City of Medical Lake Planning Department  
124 S. Lefevre St.  
Medical Lake, WA 99022  
509-565-5000  
www.medical-lake.org

## NOTICE OF DECISION

**File:** LU 2024-025 PP PU CA (Preliminary Plat, Planned Unit Development, and Critical Area Review)

**City Council Decision:** Denial of a preliminary plat for a 101-lot subdivision at the intersection of S Lefevre Street and Green Gate Lane, parcel number 14192.0002. This decision is final unless appealed.

## PROPOSAL

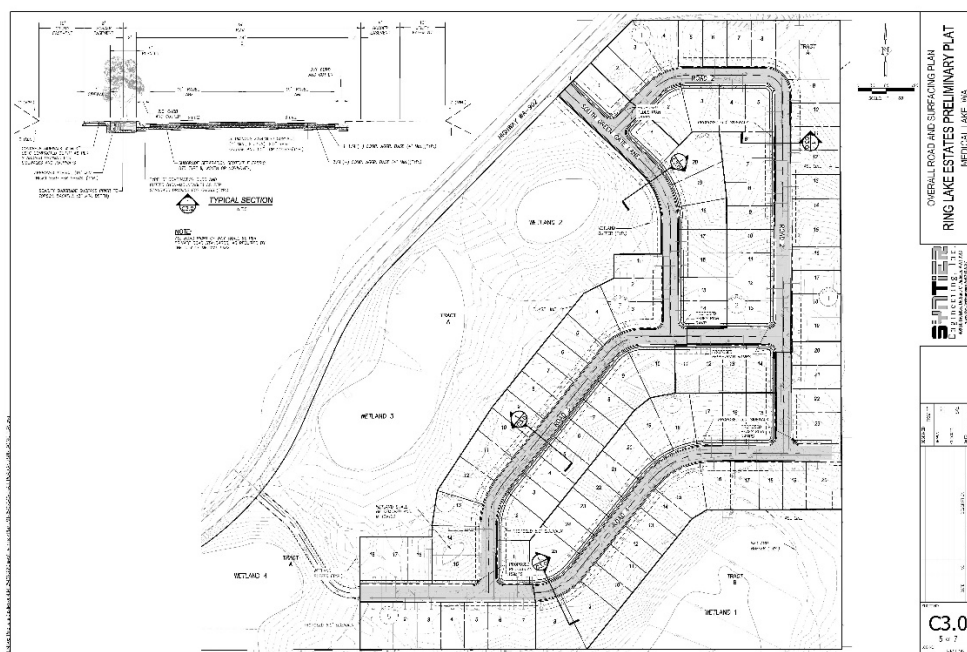
The applicant proposes to divide a 38.25-acre parcel of land into 102 lots for the purpose of single-family residences. However, Block 1, Lot 9 is not buildable since a lift station and stormwater detention facility is proposed for that location. This lot should be a tract, distinguishing it as unbuildable. In addition, Block 3, Lot 13 and Block 5, Lot 17 have sanitary sewer facilities that need to be placed in tracts, rather than easements.

The R-1 Zone requires a minimum lot size of 6,000 square feet with a minimum lot width of 60 feet. The applicant is proposing lots as small as 5,000 square feet. Not including Block 1, Lot 9, the lots range in size from 5,000 to 9,040 square feet in size. There are 73 lots that are less than 6,000 square feet in size. The applicant may request this reduction as part of a Planned Unit Development.

The private driveway at the south end of the site is proposed to be an emergency access easement that turns into a street (Road 4) once it leaves the wetland buffer going east. There is a tract connecting “Road 4” to the existing driveway on the south property line. With the number of lots proposed, the City will require this to be a permanent entrance and exit from the subdivision.

The street and block layout standards of MLMC Chapter 15.24 require the streets to go the boundaries of the site to accommodate future development. At this time, the properties to the south and east are not within the City limits of Medical Lake. The City’s 20-year projections do not include expansion on this side of town. However, because we cannot predict 50 or 100 years into the future, it is appropriate to require streets to the boundaries of the property so as not to preclude needed development in the distant future. Therefore, instead of a tract, the City will require dedicated right-of-way from “Road 4” to the south property line. For the purpose of connectivity no matter how distant in the future, the City will also require a dedicated right of way to connect “Road 2” to the east property line in the northernmost portion.

All of the proposed streets are designed as local access streets. Local access streets are required to have a fifty (50) foot right-of-way. Within the right-of-way, there shall be thirty two (32) feet of paved roadway, curbs (not rolled) and five (5) foot sidewalks. The proposed land division has public streets with a right-of-way width of thirty eight (38) feet. Within this right-of-way, it is proposed that there be thirty (30) feet of paved roadway, a rolled curb on one side and gravel on the other. Ten (10) foot easements are proposed on both sides of the right-of way to accommodate a swale on one side and sidewalks on both. The applicant may request this configuration as part of a Planned Unit Development. Roadside swales are not addressed in the MLMC, however, due to drainage issues in this area, the City asked the applicant to consider drainage swales between the curb and the sidewalk.

Lots are required to be sixty (60) feet in depth. All the proposed depth of lots are 100 feet or greater. Building setbacks are required to be shown on the plat, however, the proposal shows only a sample lot with setbacks. This is a concern due to the proposal having sidewalks in an easement, rather than the right-of-way. Front setbacks are normally measured from the front property line, not the back of sidewalk. This would allow residences to be constructed closer to the sidewalk than normal. This is a particular concern for garage entrances. If a garage entrance is twenty (20) feet from the property line, then it is likely that a vehicle parked in the driveway would block the sidewalk, which would be in violation of MLMC Chapter 11.12.

The original application had stormwater piped from drains in the streets to swales (some in the wetland buffers). Upon the request of the City, the applicant was asked to explore drainage swales on the side of the roadway between the curb and the sidewalk. This request is due to known water filtration issues in this part of the city. The applicant revised the proposal to include a ten (10) foot swale on one side of the street.

The applicant proposes to connect to the City sanitary sewer system. A sewer main is available in Jefferson Street, to the north of the site. However, this sewer main connects to the Lakeshore lift station which sends sewage to the Lakeshore main. Both of these facilities are at capacity. At this time, the City does not have a funded project to address the capacity issue for the southern portion of the City. The applicant is aware of this and has engaged in discussions regarding a solution, but has not provided a written plan for providing sanitary sewer capacity for this development.

On site, the applicant is proposing three (3) lift stations. Two (2) are on residential lots and one(1) is in a wetland buffer. These will all need to be placed in tracts outside of wetland buffers.

Sidewalks are required to be on both sides of the street, five (5) feet in width, and within the right-of-way. The applicant is proposing five (5) foot sidewalks located in easements throughout the subdivision. The City will require the sidewalks to be within the right-of-way when possible. Due to the requested roadside drainage swales, it is possible that a portion of the sidewalk will be in the required ten (10) foot utility easement. The exception is the southern entrance off Lefevre Street (SR-902). It is proposed without curbs and sidewalks. The City will require a sidewalk only on the north side of the street because this street right-of-way is running through a wetland buffer. New subdivisions are required to add a curb and sidewalk for the length of the property line abutting the existing street. In this case, the property abuts Lefevre Street (SR-902) for approximately 1800 feet. Nearly the entire length of the street frontage is in wetland buffers. For this reason, the City will not require sidewalks along the site, but rather pedestrian crossing to the Medical Lake Trail on the other side of Lefevre Street (SR-902).

The applicant proposes to provide drainage swales on one side of every street to accommodate stormwater. Overflow from these swales will be piped to outfalls with rip-rap energy dispersion in two (2) wetland buffers and a stormwater retention facility. Stormwater and a high water table poses a great concern in this area. Many residents in the southern portion of Medical Lake deal with water issues in their basements and crawl spaces. Some resort to using sump pumps to control flooding. It is illegal to connect sump pumps to the sanitary sewer system. To prevent residents who feel tempted to do so when they feel they lack options, it is appropriate to require a tap to the stormwater system for every lot. In addition, knowing the likely high water table problems in the area, it is appropriate to restrict construction of basements.

**Findings:** MLMC Section 15.24.030 requires local access street to have fifty (50) foot rights-of-way with thirty two (32) feet of paved roadway, and five (5) foot sidewalks on both sides of the street. The applicant is requesting to reduce the right-of way width to thirty eight (38) feet with a thirty (30) foot paved roadway. Due to the reduced right-of-way, the applicant is proposing to have the sidewalks located in a public easement. In early conversations, the City asked the applicant to consider stormwater drainage swales between the curb and sidewalk on both sides of the road. The proposal has a swale on one side of the road with the explanation that it will require less piping under the roadway.

The request to reduce the right-of way width and put the sidewalks in easements benefits the developer in the short-term, but does not benefit the City or the residents in the long-term. **For this reason, this criterion is not met.**

**Findings:** The R-1 Zone, as specified in MLMC 17.16, requires lots to be a minimum of 6,000 square feet with a minimum width of sixty (60) feet. The applicant is requesting the minimum lot size to be reduced to 5,000 square feet with a minimum width of fifty (50)s feet. The proposed layout includes seventy-three (73) lots that are less than 6,000 square feet. There are many concerns regarding stormwater and groundwater on this site. The more impervious area created, the more issues that will have to be overcome. Having smaller lots will increase the number of houses, driveways, and other impervious surfaces such as patios and sheds. The increased stormwater runoff from and increased impervious surface area is a negative impact for both the future residents and the surrounding property owners. **For this reason, this criterion is not met.**
